### **Design Review Board Meeting**

**Tuesday, November 26, 2024, 2:30 PM**

**Two Park Lane  
Sign System  
November 26, 2024  
DRB-001507-2024**

## DESIGN TEAM/DRB COMMENT SHEET

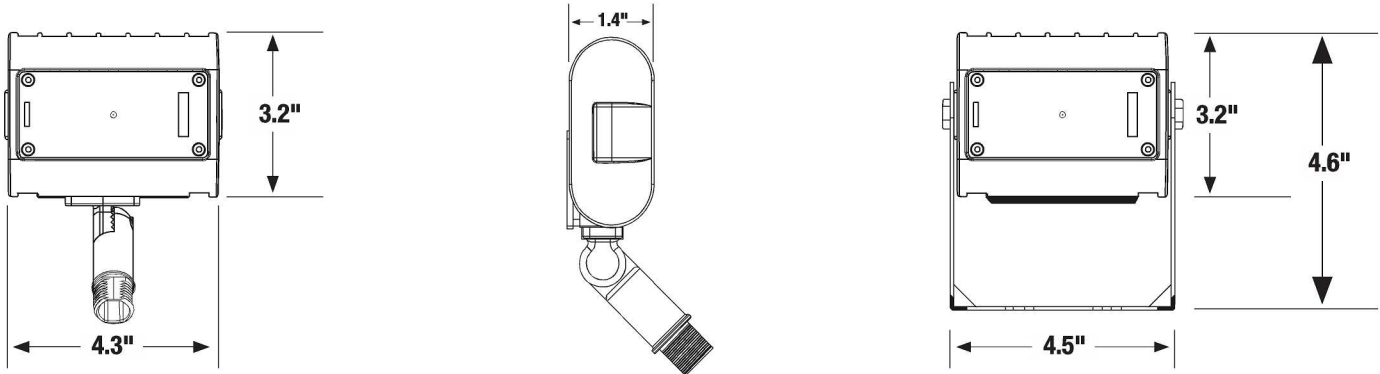
| DRB REQUIREMENTS                                     | Complies Yes                        | No                       | Not Applicable                      | Comments or Conditions                                                   |
|------------------------------------------------------|-------------------------------------|--------------------------|-------------------------------------|--------------------------------------------------------------------------|
| Demolition Plan if needed                            | <input checked="" type="checkbox"/> | <input type="checkbox"/> | <input type="checkbox"/>            | The secondary sign facing Park Lane will be demolished and not replaced. |

DEMO PLAN

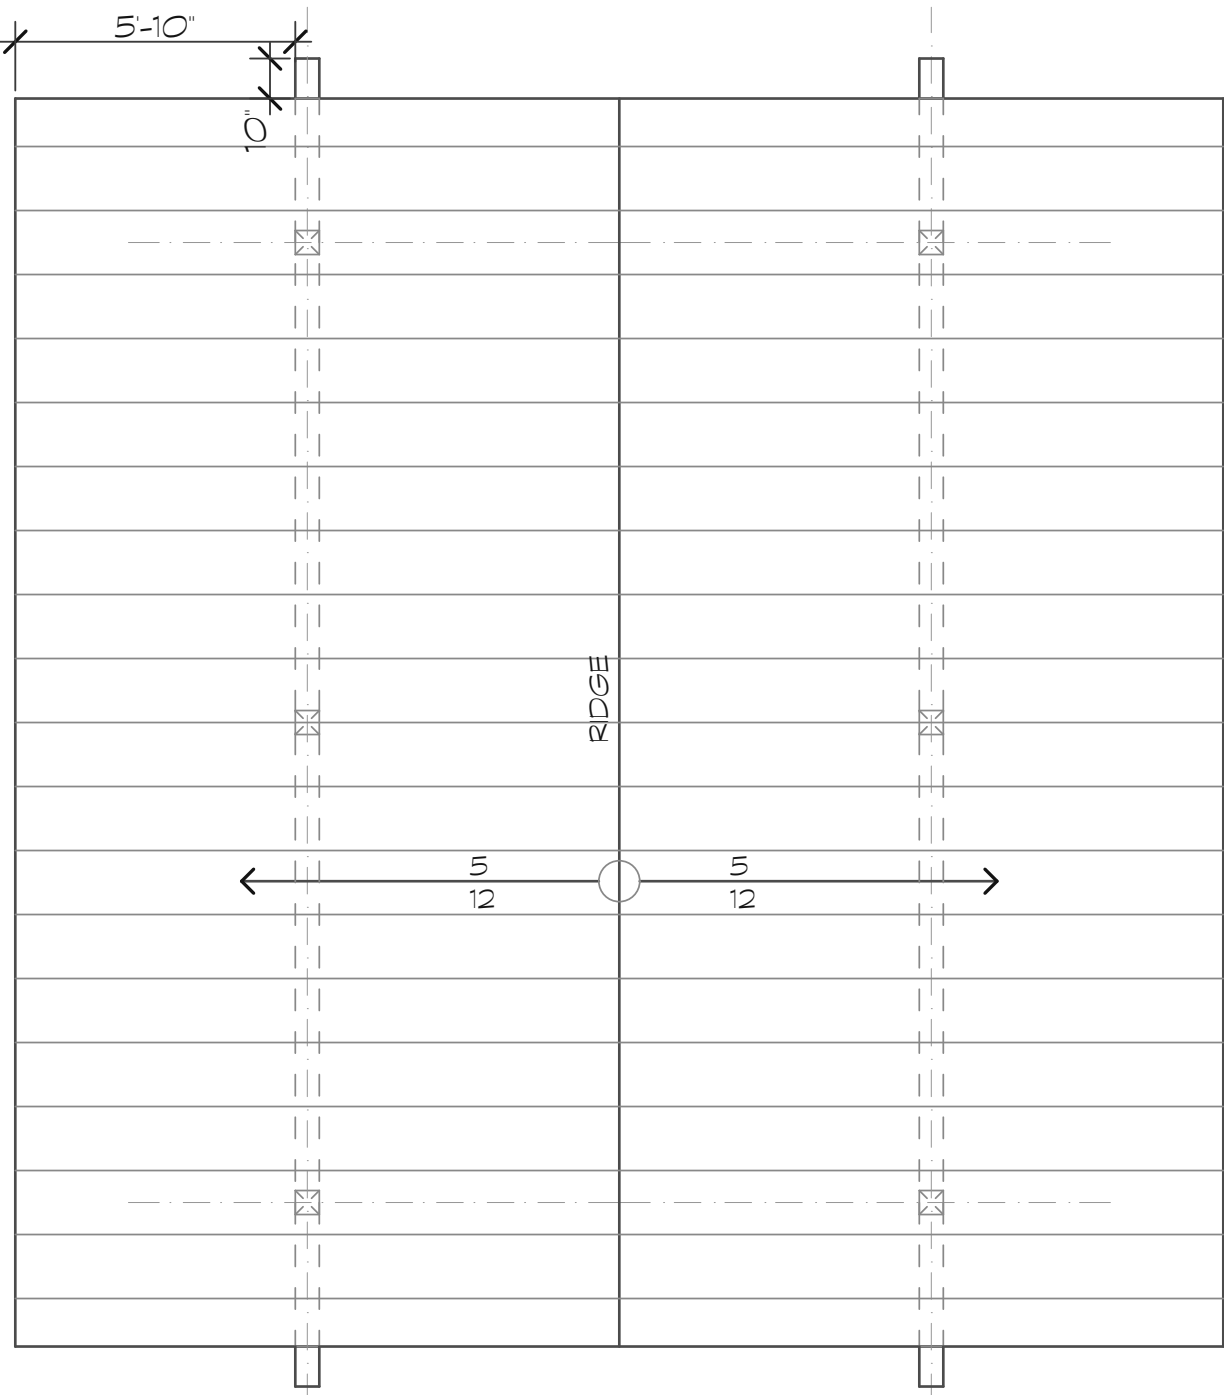
| DRB REQUIREMENTS                                     | Complies Yes                        | No                       | Not Applicable                      | Comments or Conditions                                      |
|------------------------------------------------------|-------------------------------------|--------------------------|-------------------------------------|-------------------------------------------------------------|
| Demolition Plan if needed                            | <input checked="" type="checkbox"/> | <input type="checkbox"/> | <input type="checkbox"/>            | The applicant is demolishing the existing covered bar area. |

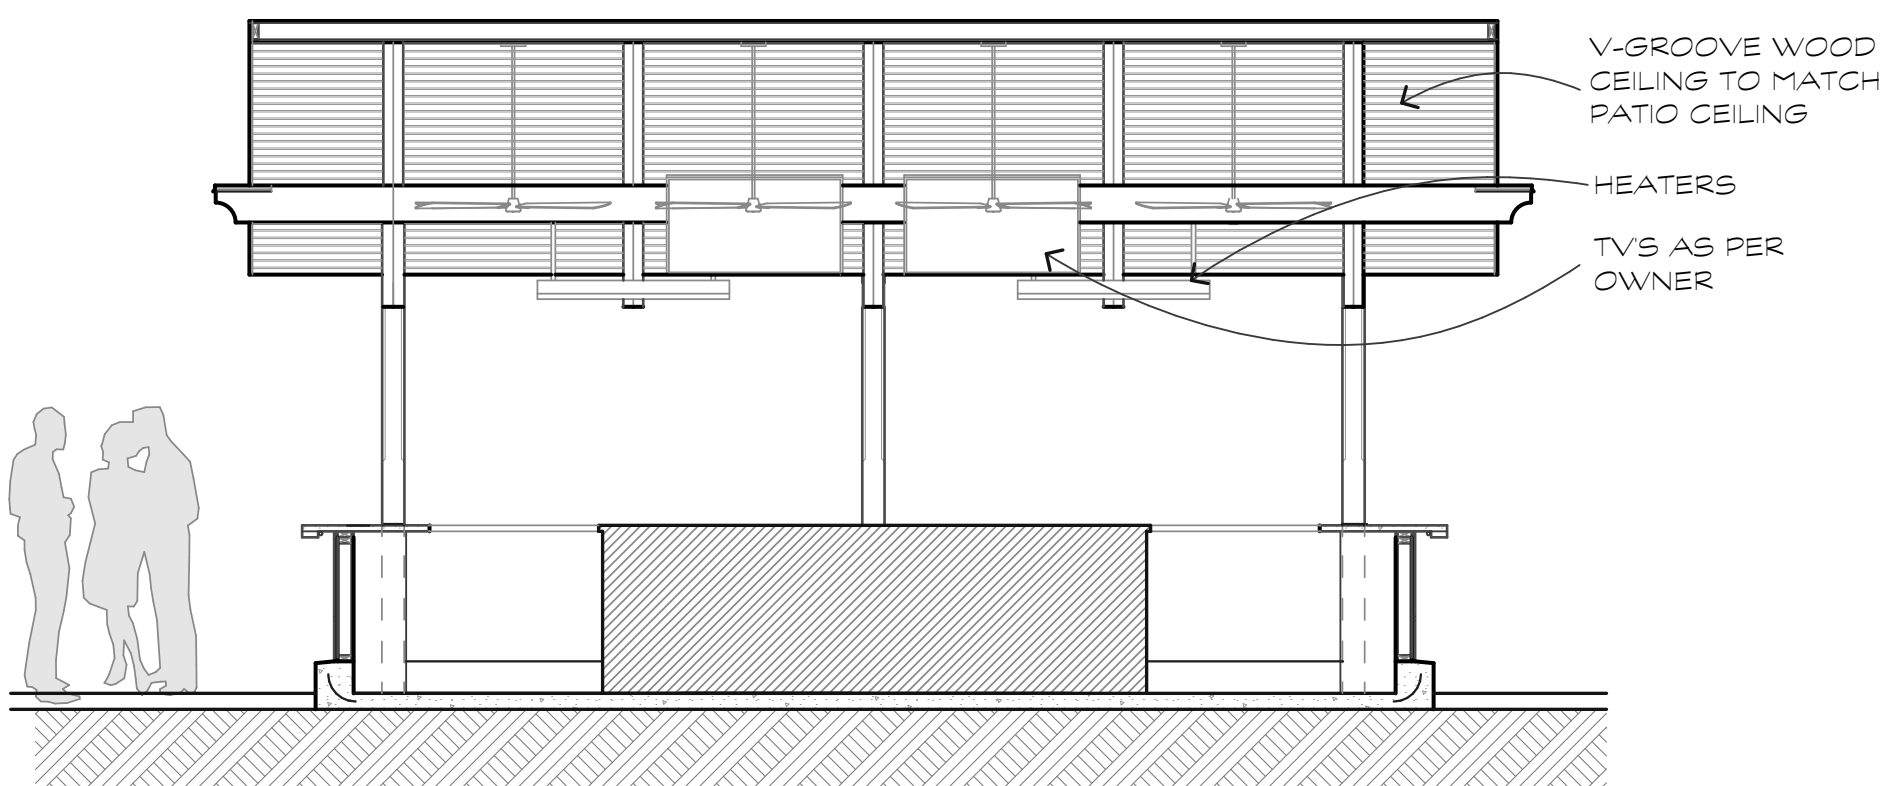
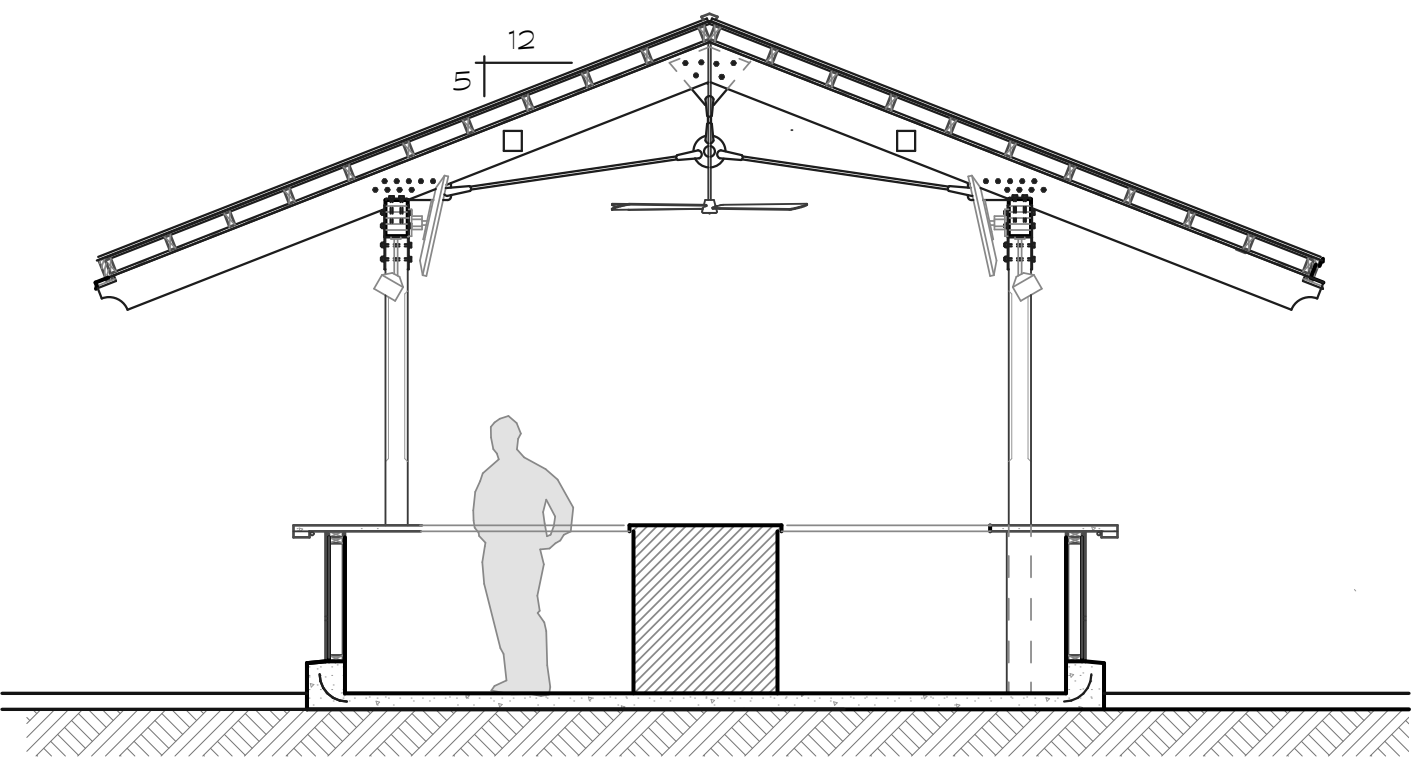
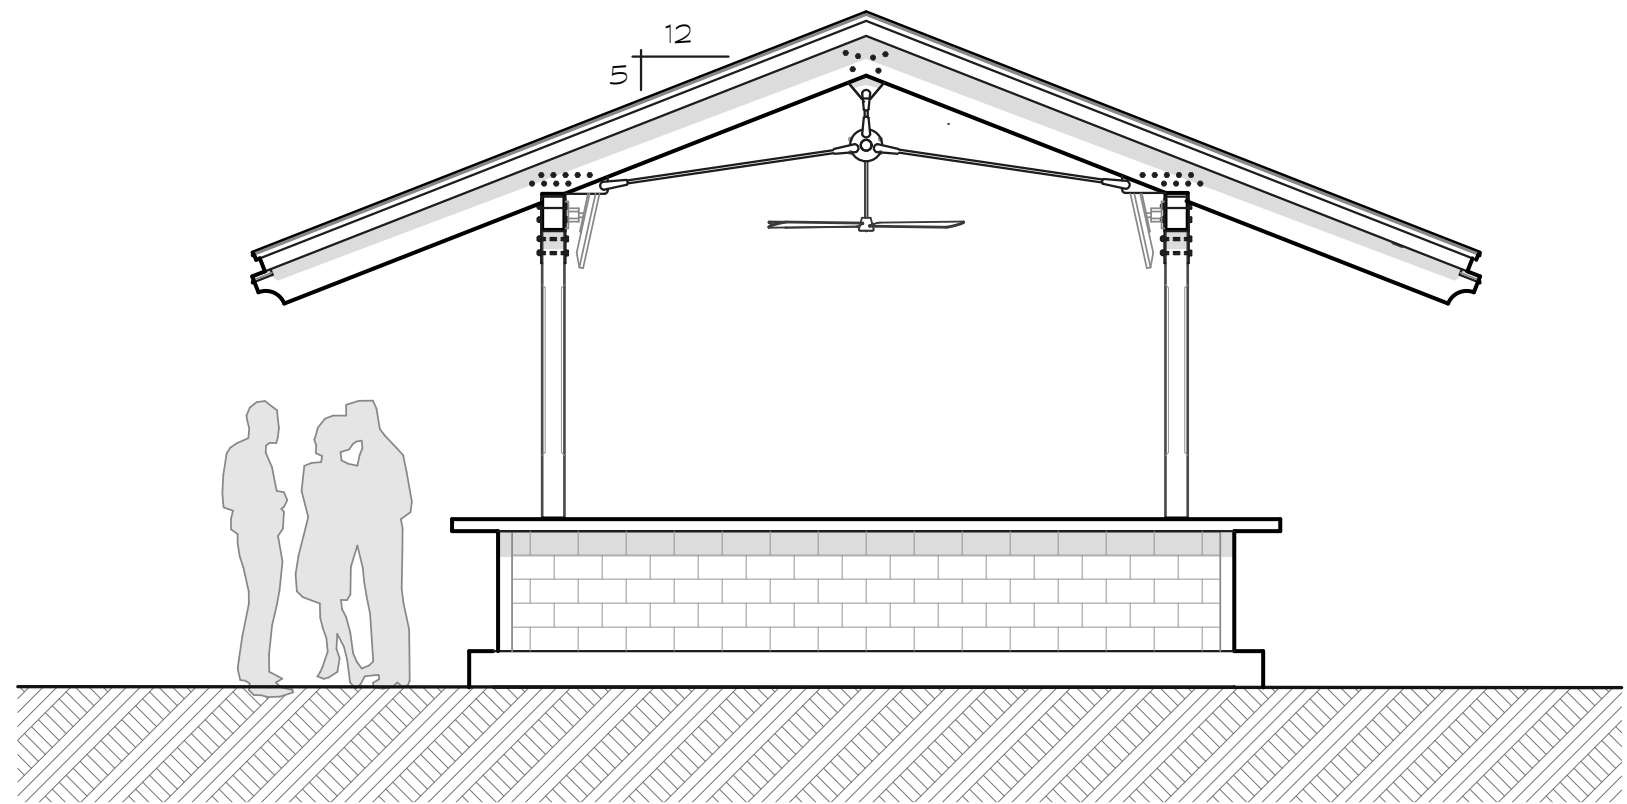
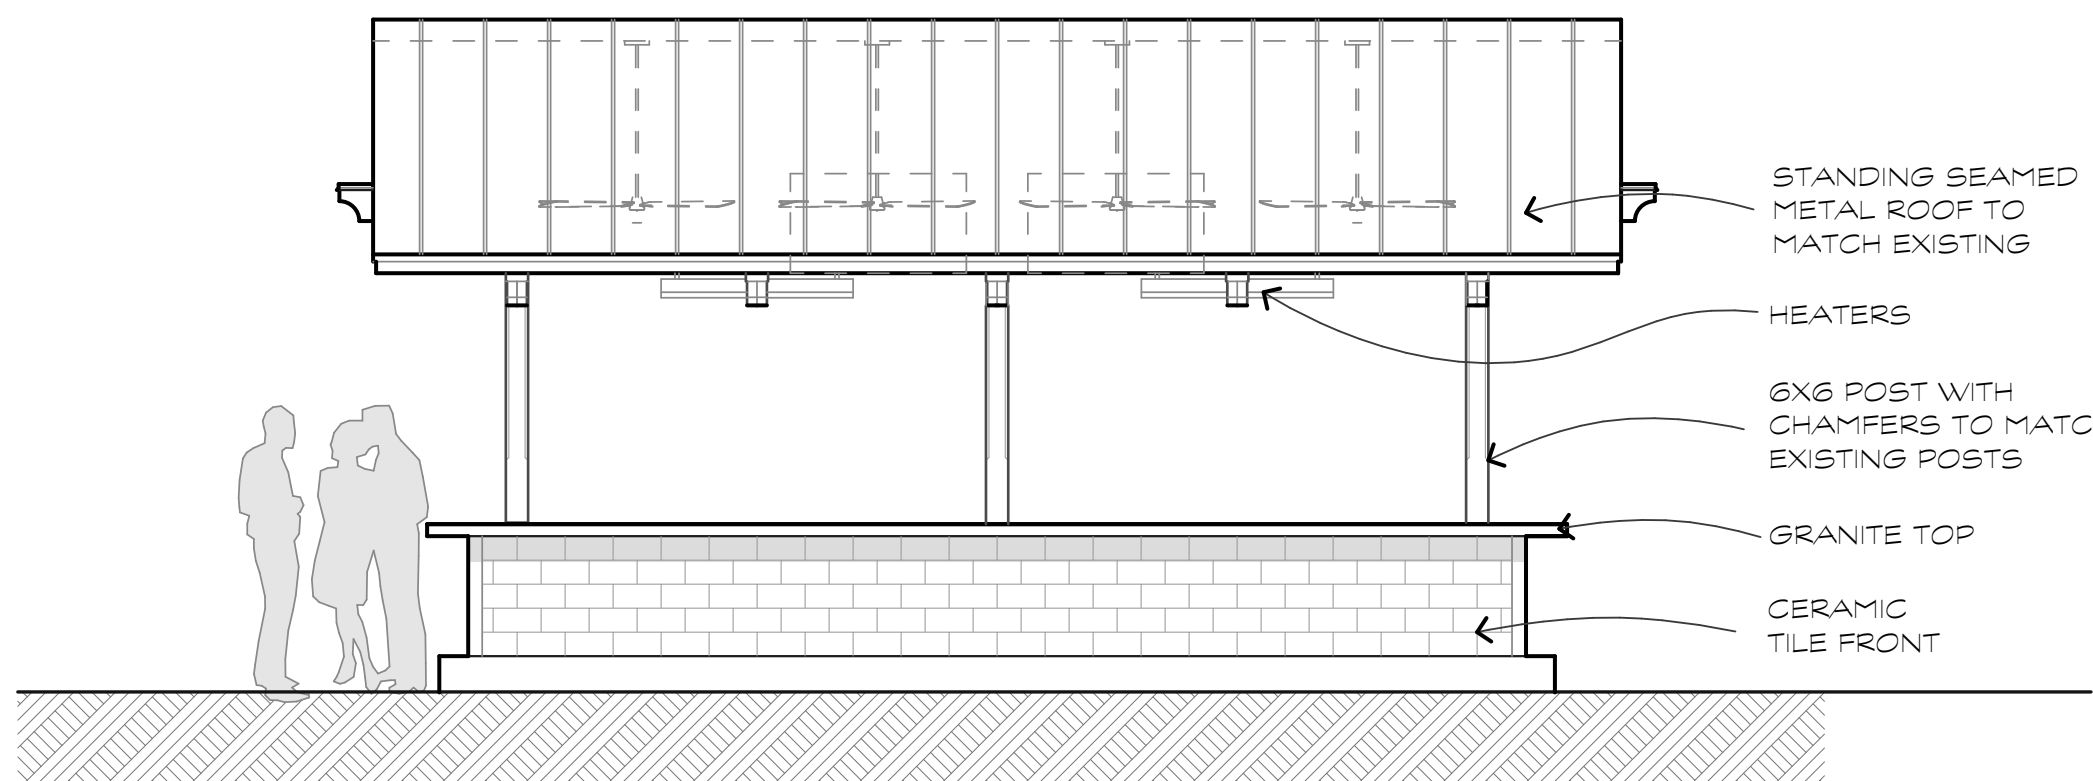
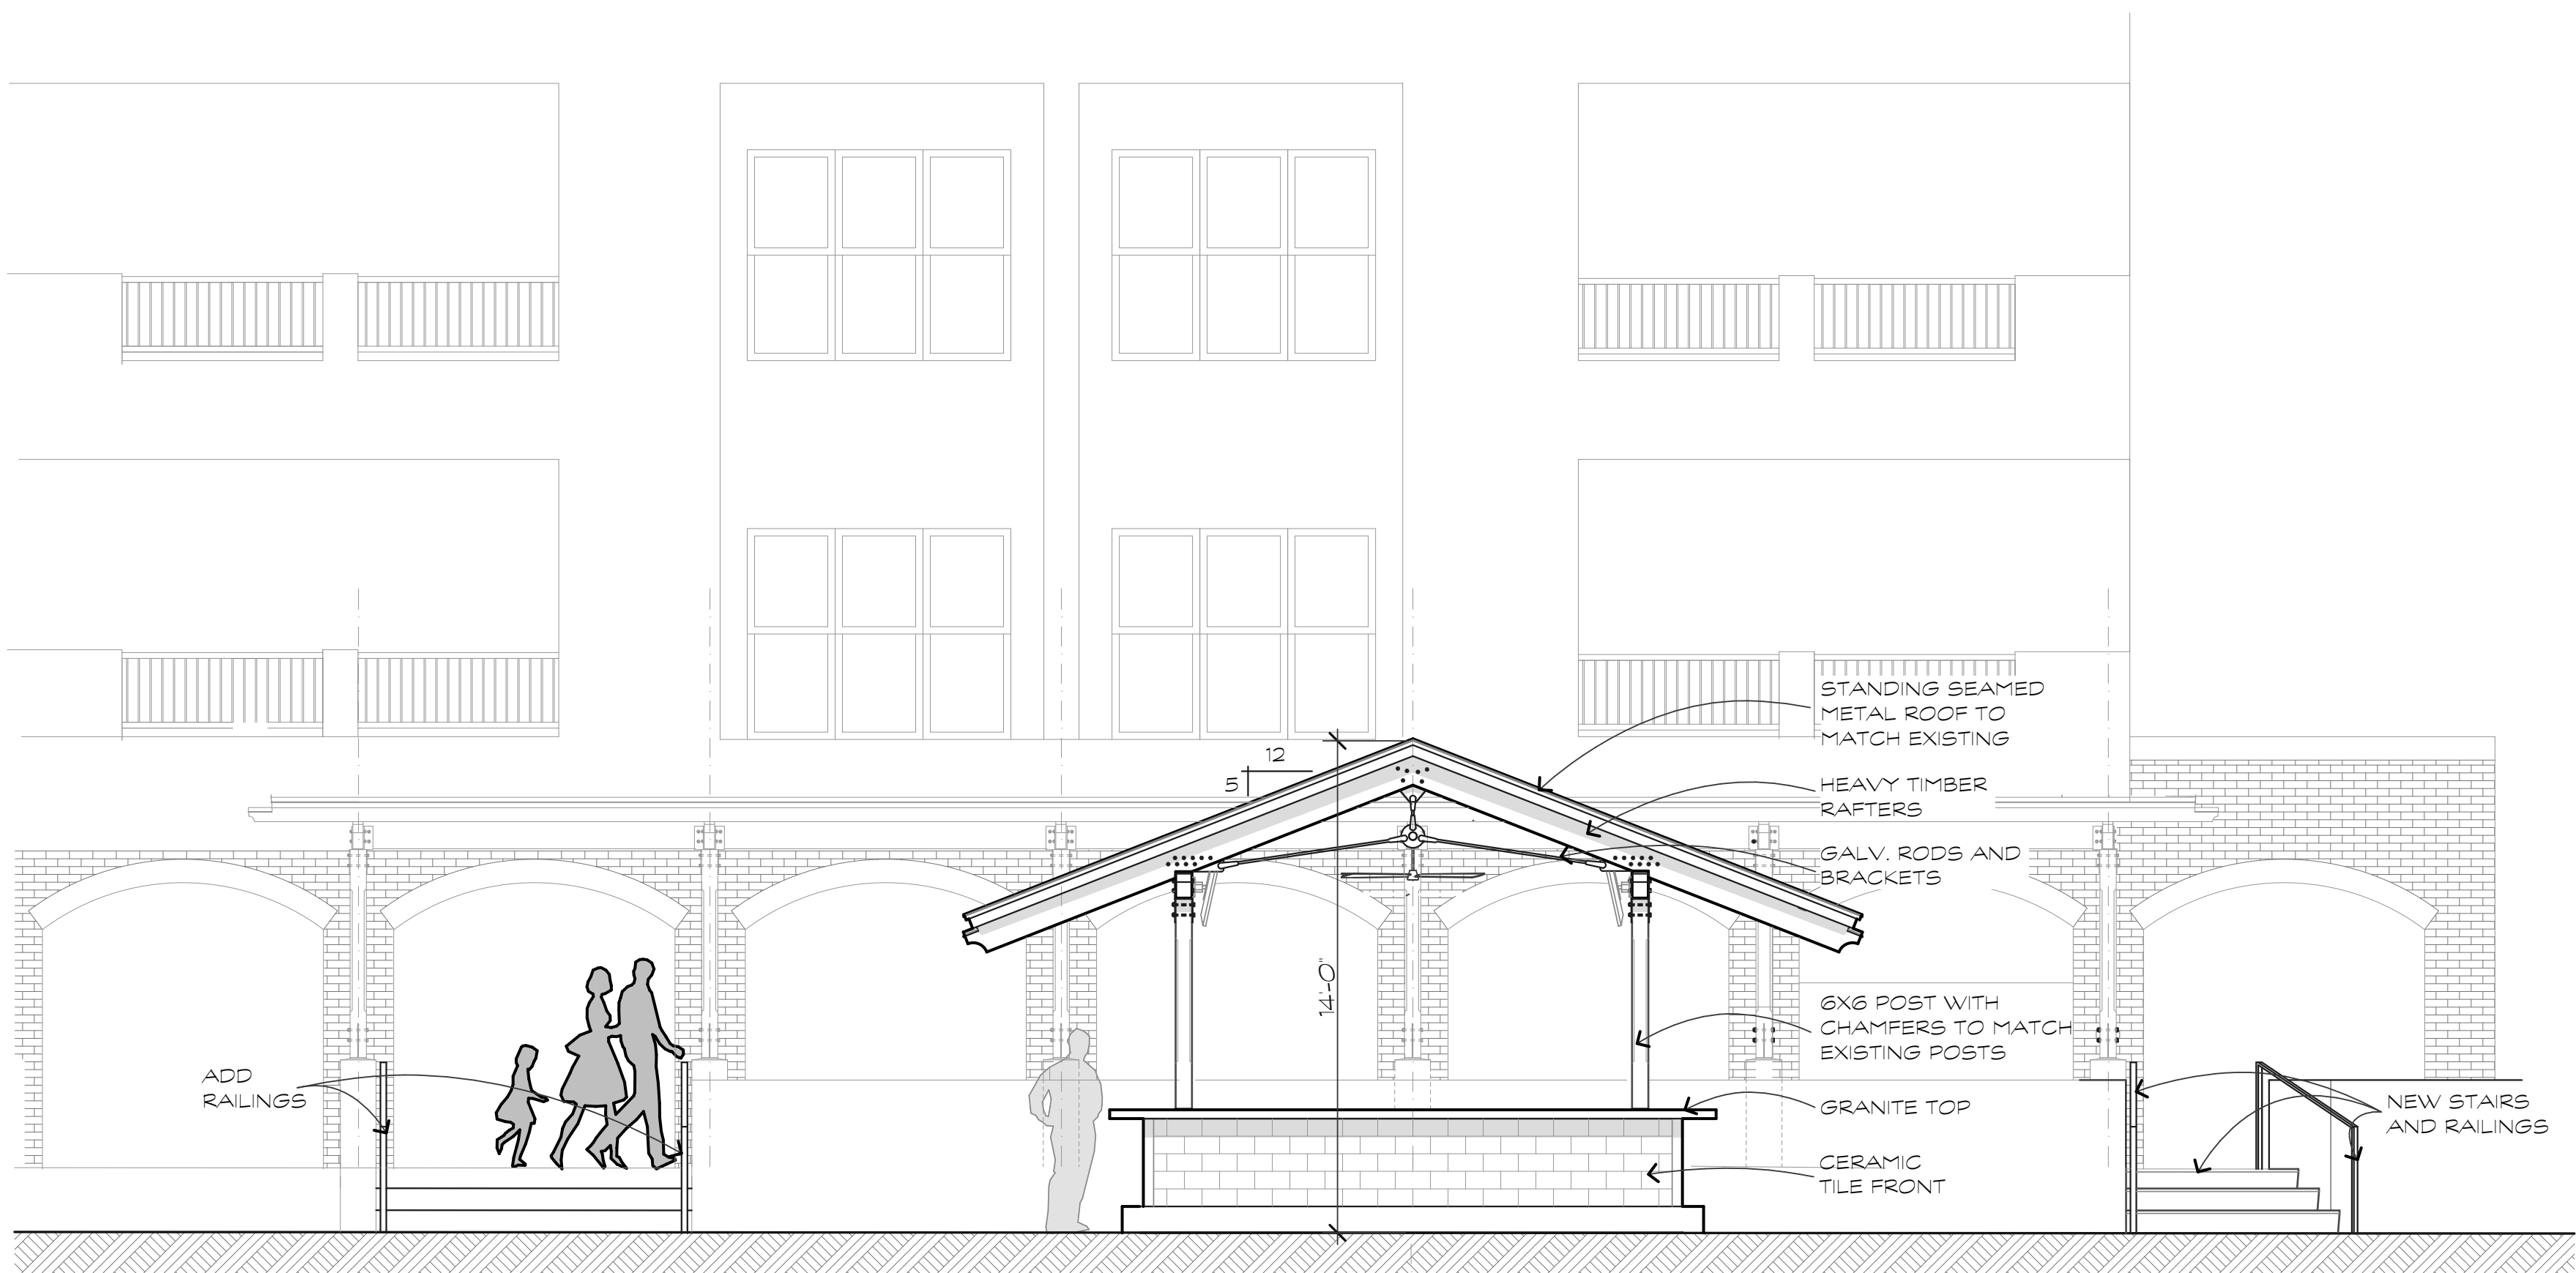
1. Staff recommends approval of the conceptual design submittal with the following conditions:
2. Provide rendered elevations with the materials showing.
3. Provide a 11” x 17” materials board for all materials being used.
4. Any additional information as required by the Board.
